10 OLD STAGE ROAD

Subject: 10 Old Stage Road
Final Plan Review

Re: Hayward Design Build (10 Old Stage Road)

A-6

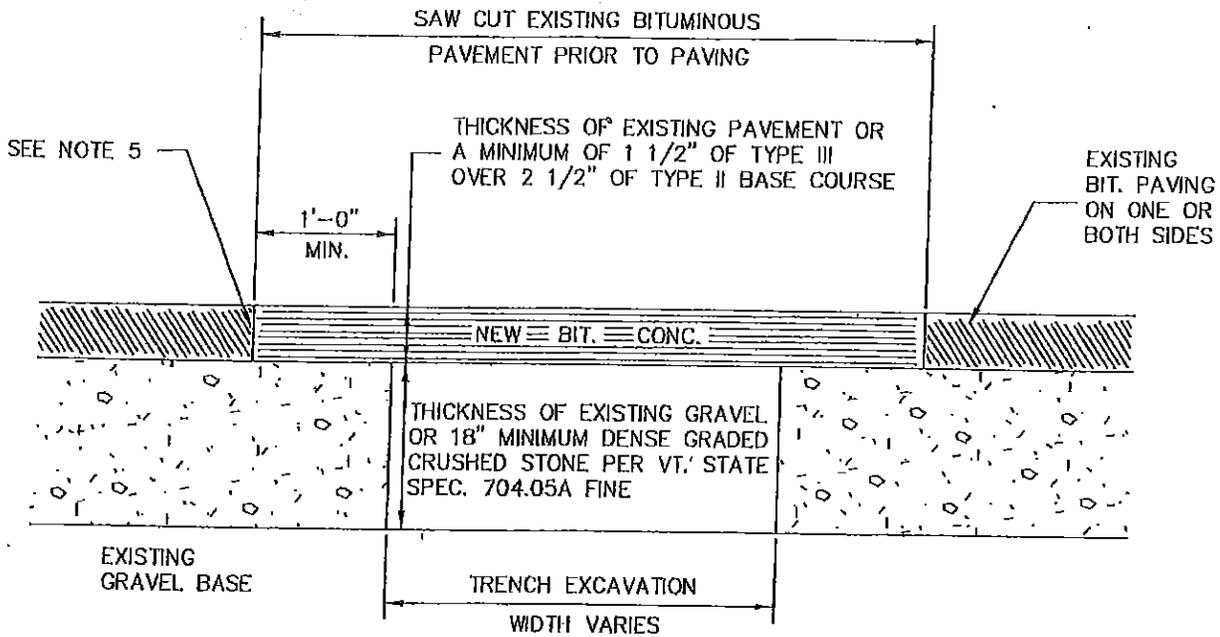
- **Sidewalk Detail:** This detail requires some modification. Refer to attached Public Works Detail A-6 for further direction. The Cast Iron Detectable warning plate must be installed in concrete. Also, the detail only shows 6" of cover over the top of the pipe. Not acceptable. Public Works would accept this amount of cover if the material for the 18" culvert is switched to SDR 35 PVC.

1. The house connection detail has added Notes #3 and 6 from A-33.
2. The hydrant detail has been updated to include more information on cover depth, the thrust block size and drain plug from A-30.
3. The water main detail has been updated to provide the necessary cover and a test procedure.
4. The pipe specification has been revised to provide for C-900.
5. The sidewalk detail has been revised to provide a concrete section to connect Old Stage Road and the existing sidewalk. The culvert material has been changed to SDR 35 PVC.

A-11

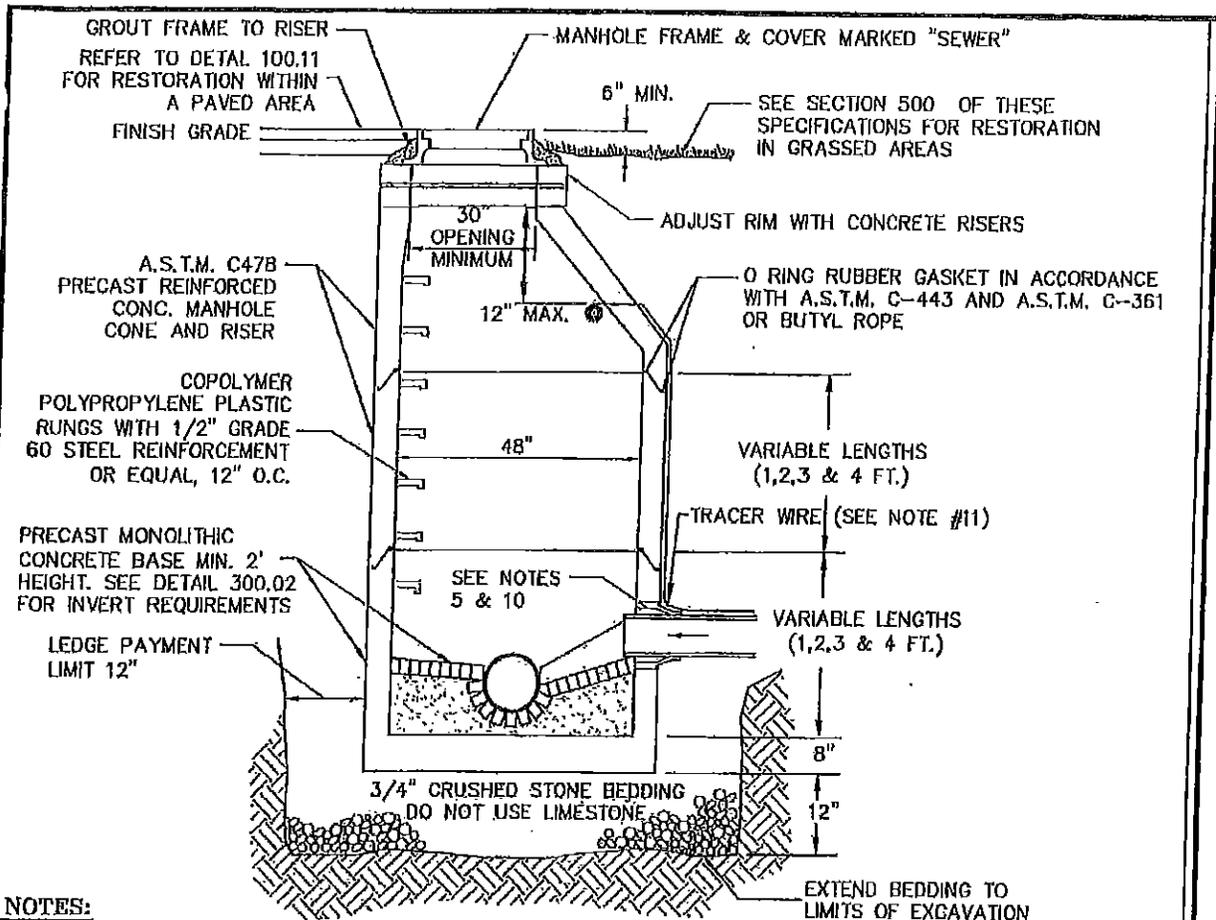
- **Fire Hydrant Detail:** Add note #11 from attached Public Works Detail A-20.
- **Forcemain Sewer Detail:** Add note #2 from attached Public Works Detail A-24.
- **Forcemain Connection Notes:** The backfill procedures are not acceptable. Refer to attached Detail A-11. Public Works will accept nothing less that what is provided within this detail.

1. The manhole detail has been updated to include the Note #11 information from A-20.
2. The force main testing procedure from A-24 has been added to the detail.
3. The Craftsbury Court road cut detail has been updated to reflect detail A-11.

A-30

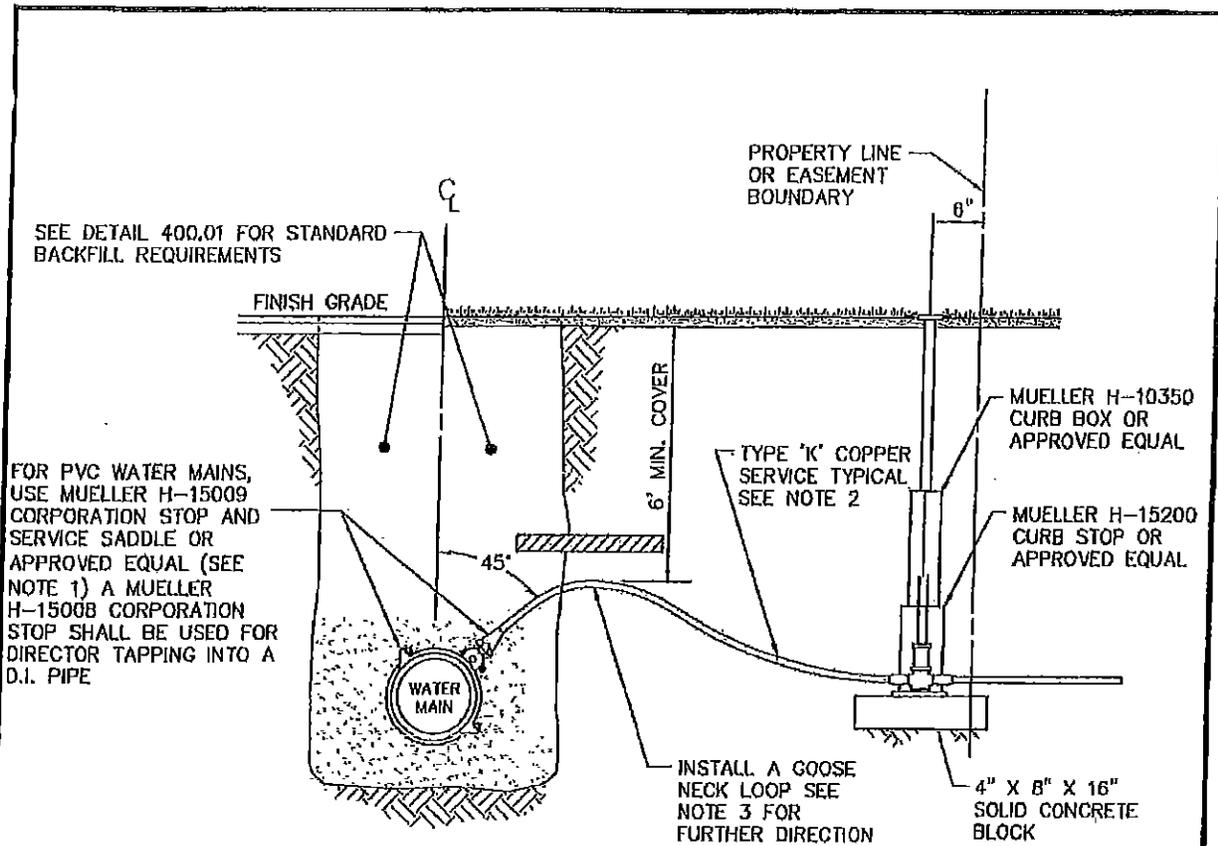
- **House Connection Detail:** Add notes #3 and #6 from attached Public Works Detail A-33.
 - **Fire Hydrant Detail:** Add the following notes to the detail. Refer to attached Public Works Detail A-30 for further direction.

- A measurement from finish grade to top of pipe noting the minimum cover of 6'-0".
 - The thrust block at the 8X8X6 Tee must have a 16 SF thrust block.

- A note clearly showing the drain plug and noting the plug to remain.
 - **Water Main Installation Notes:** The testing procedures stated in Note #5 are not AWWA compliant. Please update. Also, Note #6 allows for less than 6' of cover. The waterline will be installed with a minimum of 6' of cover. Public Works will not accept any new waterlines with less than 6' of Cover.
